**WATER & SEWER
COMMISSION**

December 21, 2018

RE: Third Modified Consent Decree Civil Action No. 76-cv-02184-RGS
LWSC Preliminary Design/ West Lynn Sewer Separation

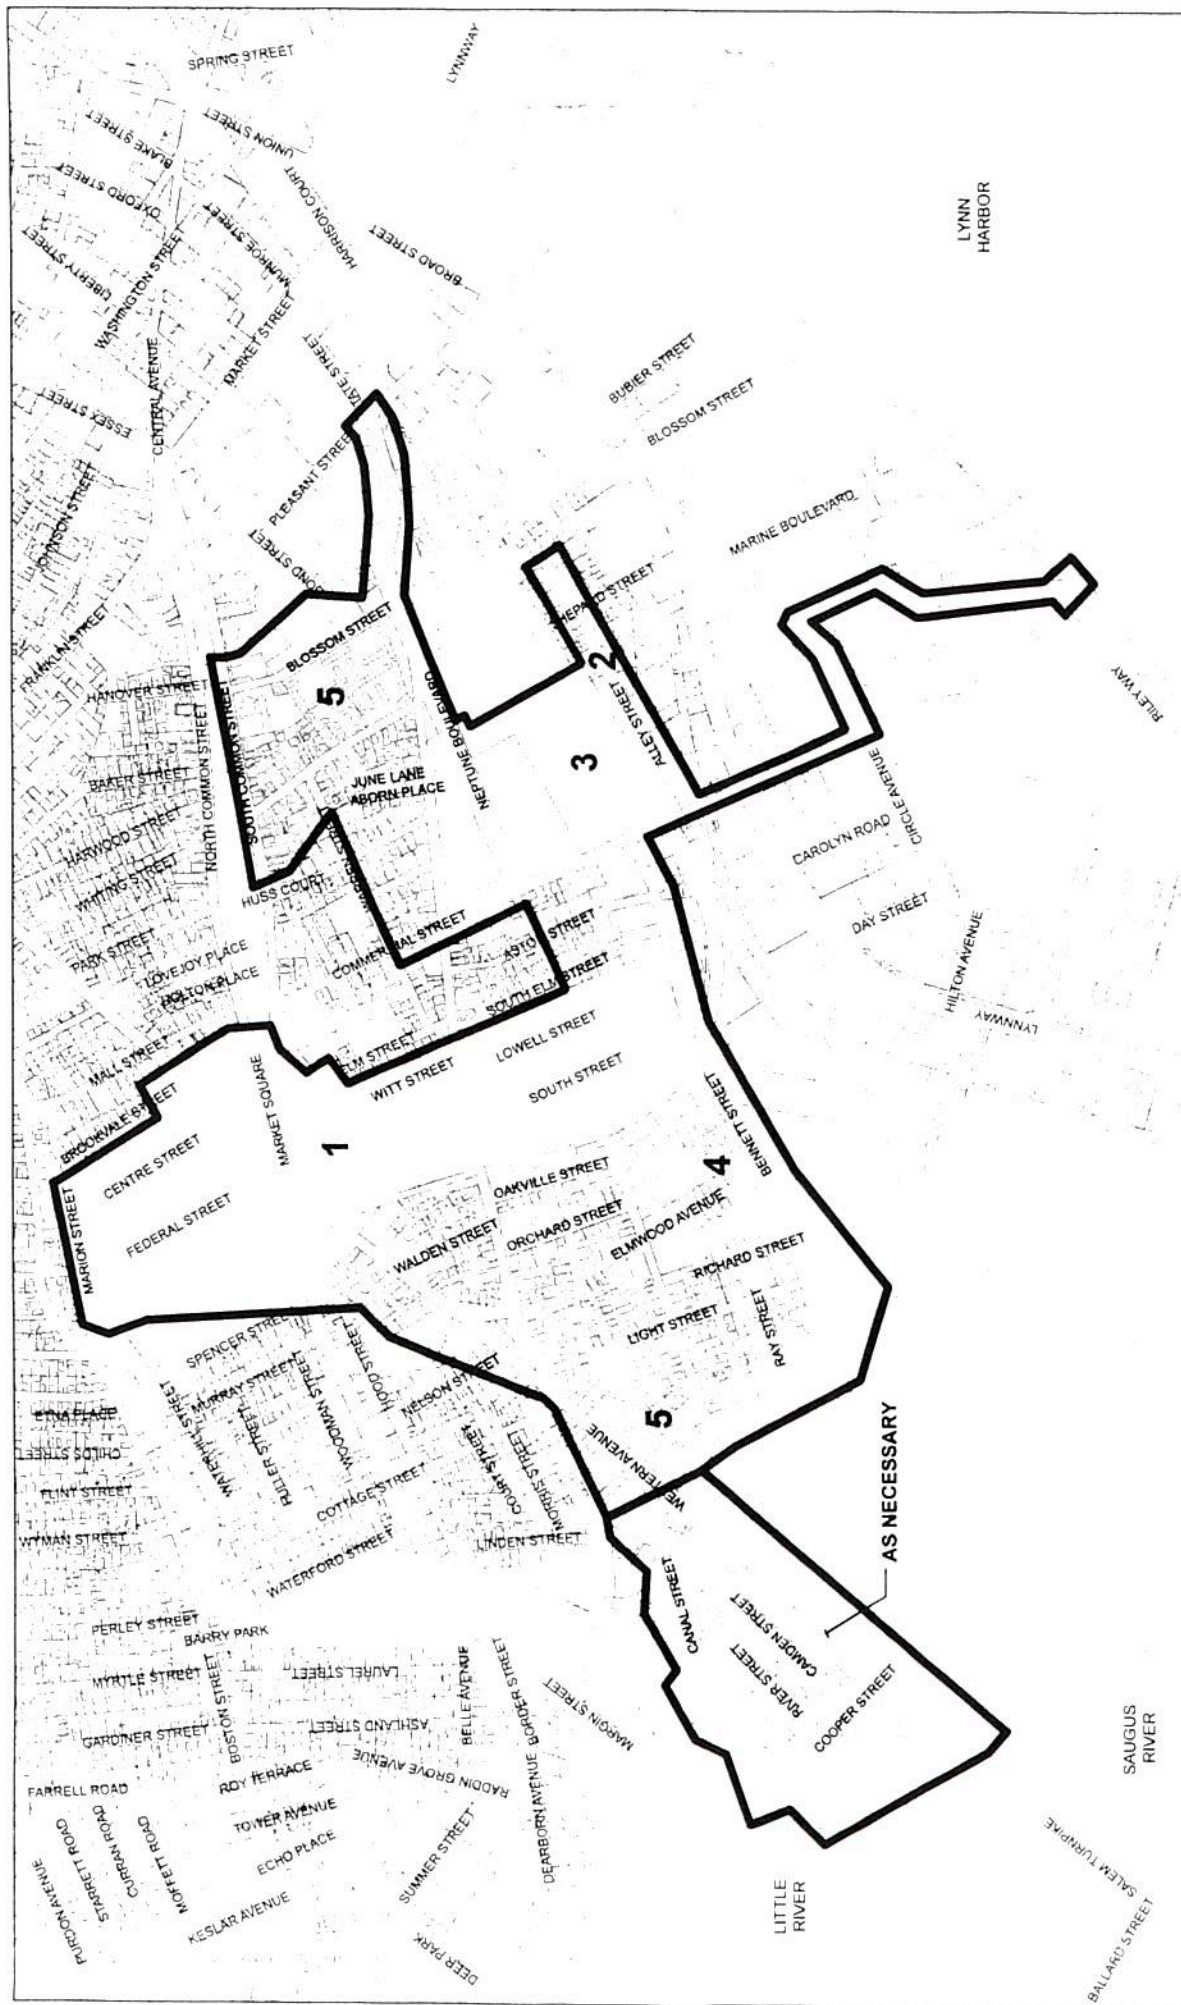
LWSC should provide a map showing the geographic locations of the proposed work, as the phasing of the sewer separation work outlined in Appendix K has not clearly been delineated on any figures.

RESPONSE: The attached map depicts the proposed phasing of sewer separation work.

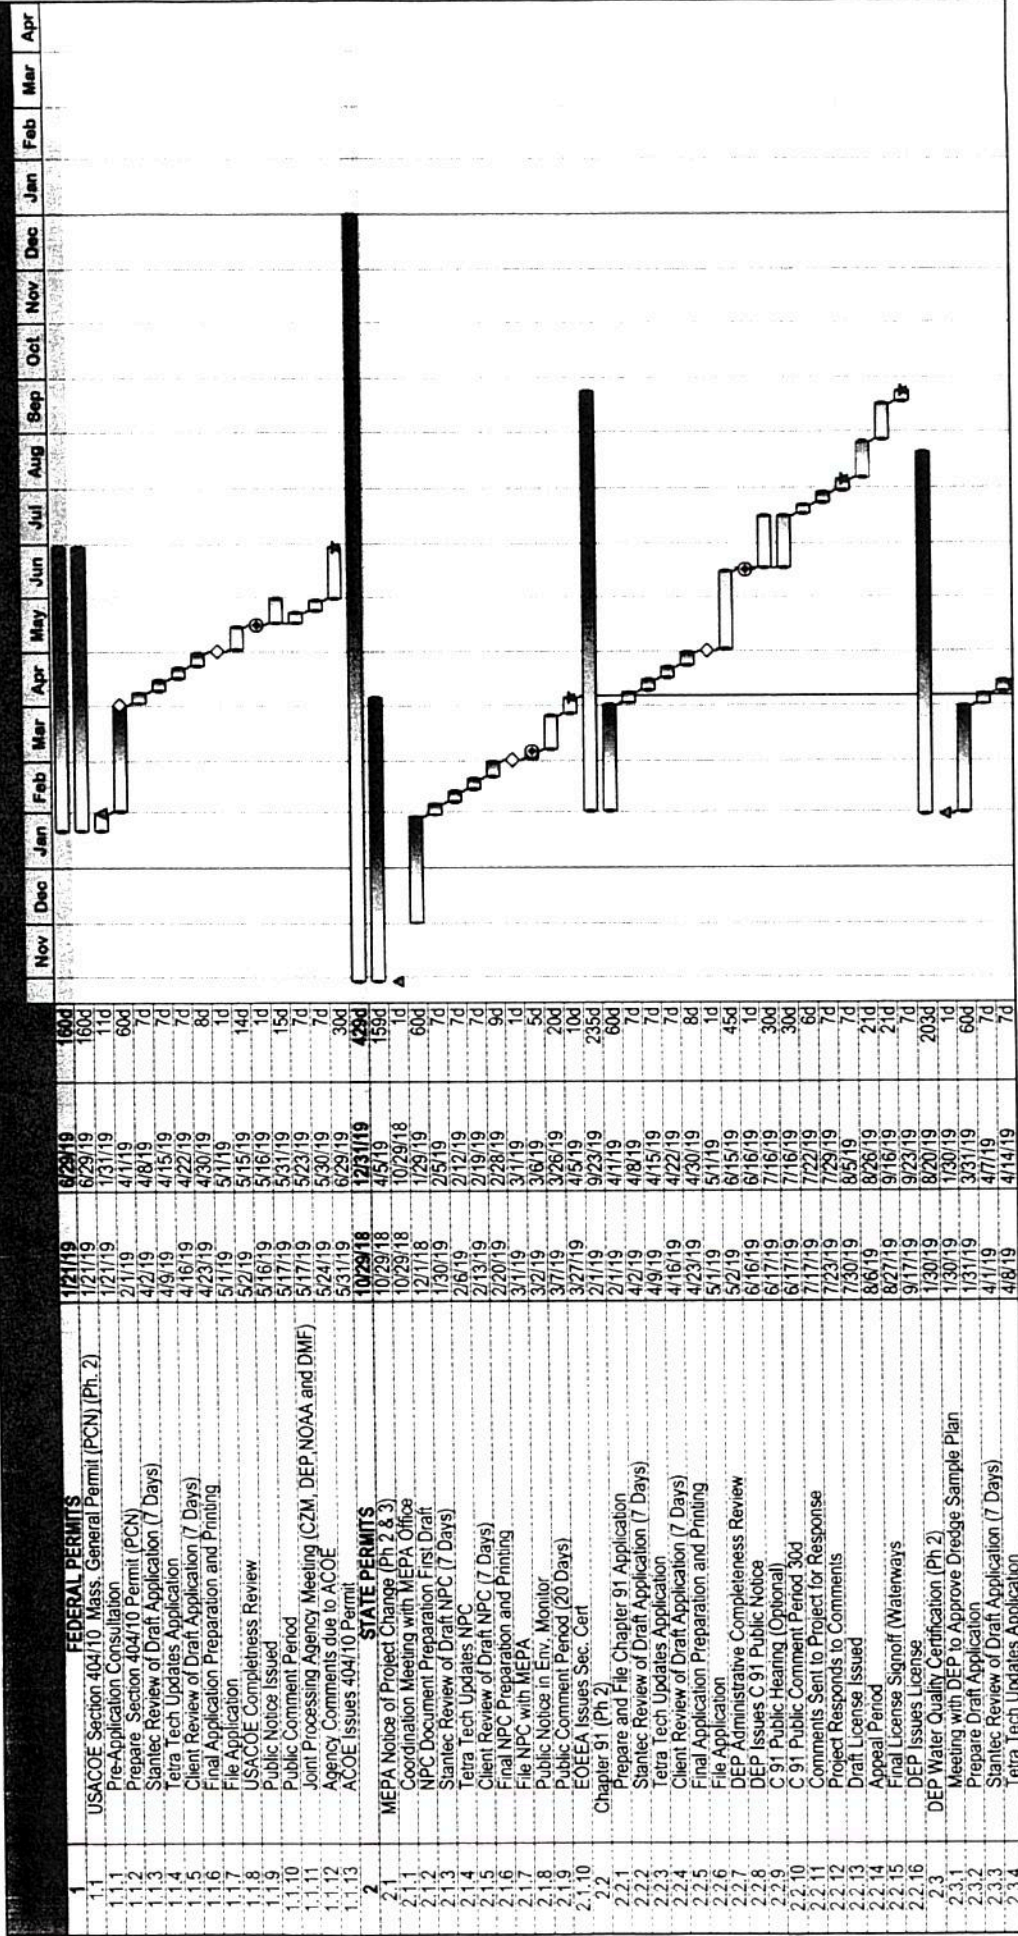
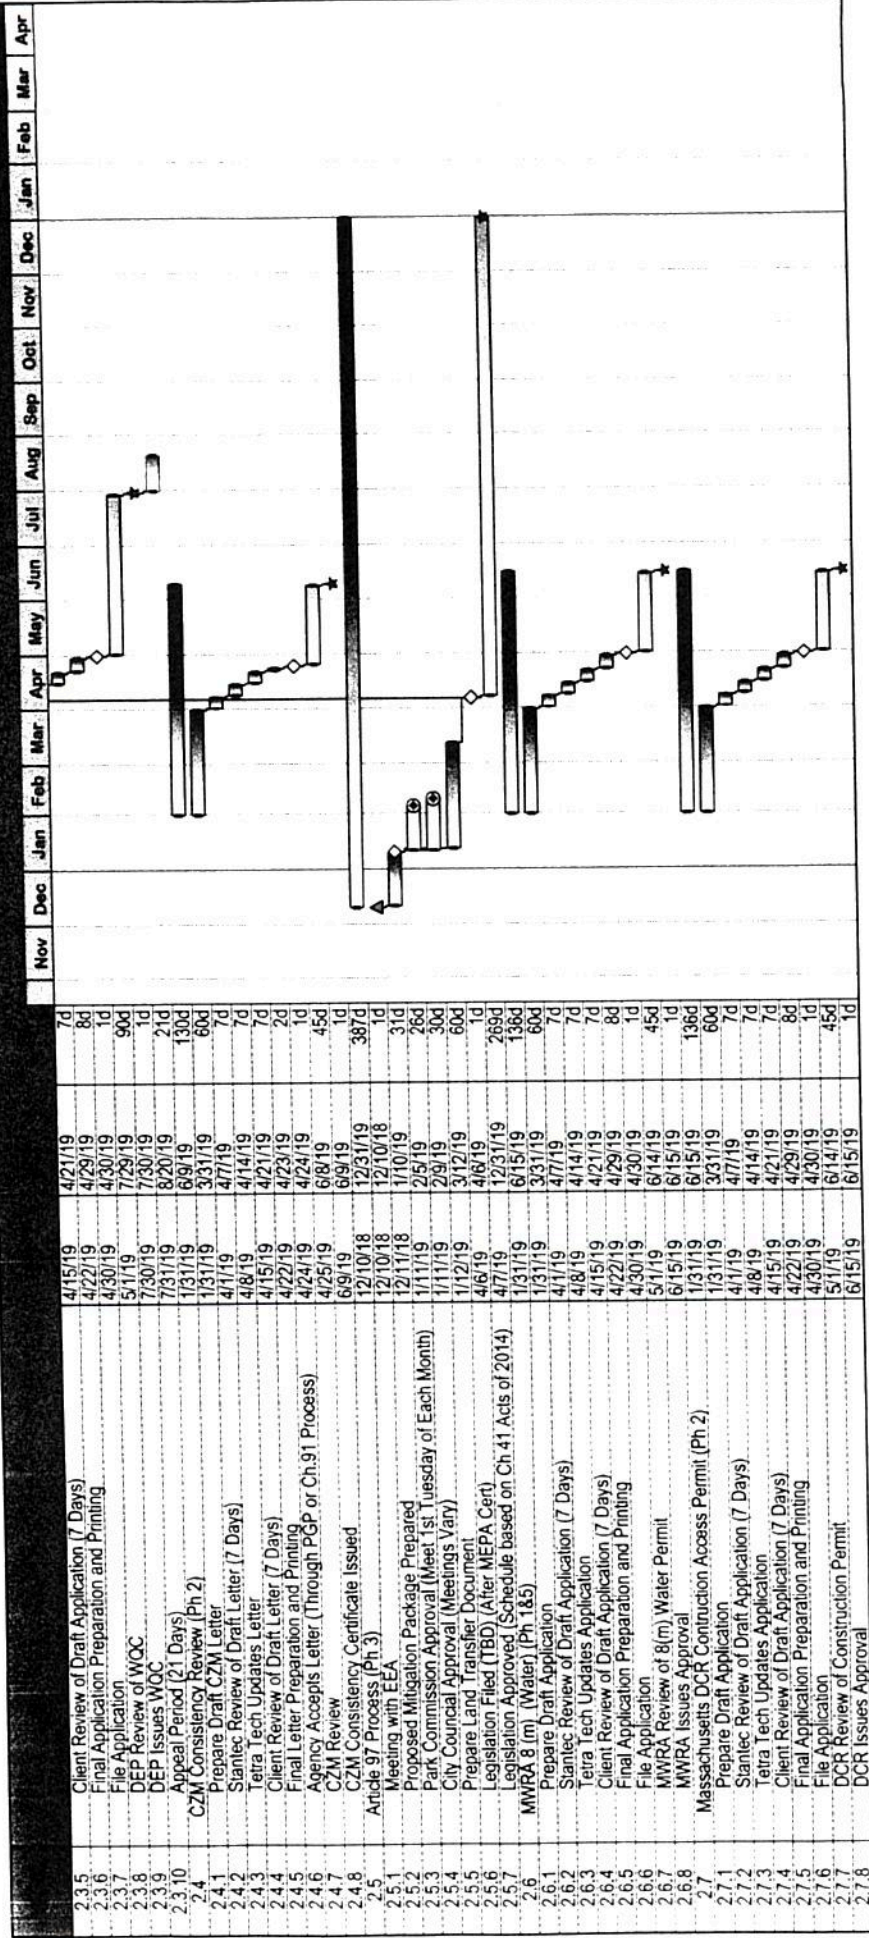
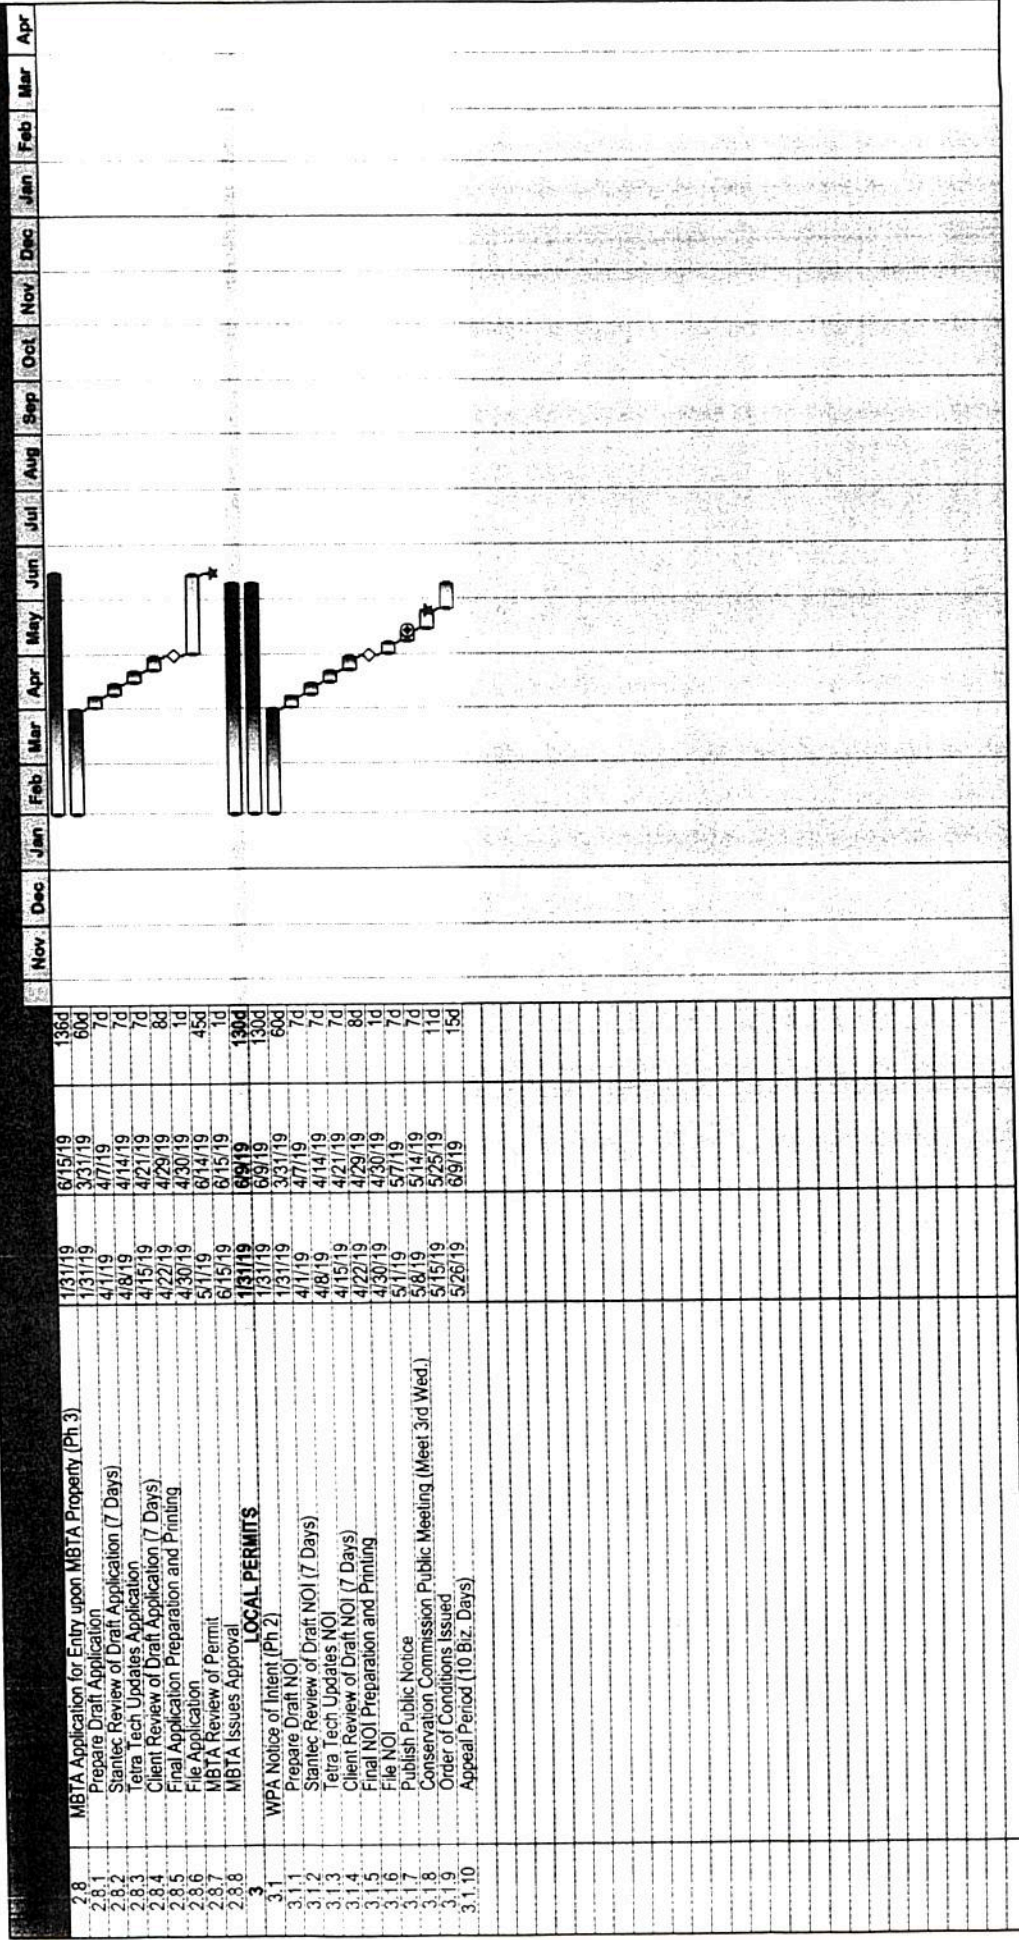
A separate chart with actual milestone dates should be provided with the information in Table 15-1 so that it can be transposed or compared with the implementation schedule in Appendix K, as there seems to be inconsistencies. This will allow all parties to be aware early on of any pending schedule issues.

Only the Phase I work shown in Appendix K has any review time for MassDEP (or EPA), with others going right from 100% design into bidding. A minimum of 45 days should be included for regulatory review of plans/specifications for each phase of the project work. Additional time may be required to resolve any serious technical issues.

RESPONSE: Please find attached updated versions of Table 15-1 and the Appendix K phased implementation schedule, along with the requested companion permitting schedule that aligns with those documents. The updated schedule has been adjusted to show a MassDEP (or EPA) review time. There is sufficient time in the design and construction schedule for these reviews and MEPA reviews without altering the construction completion milestones.
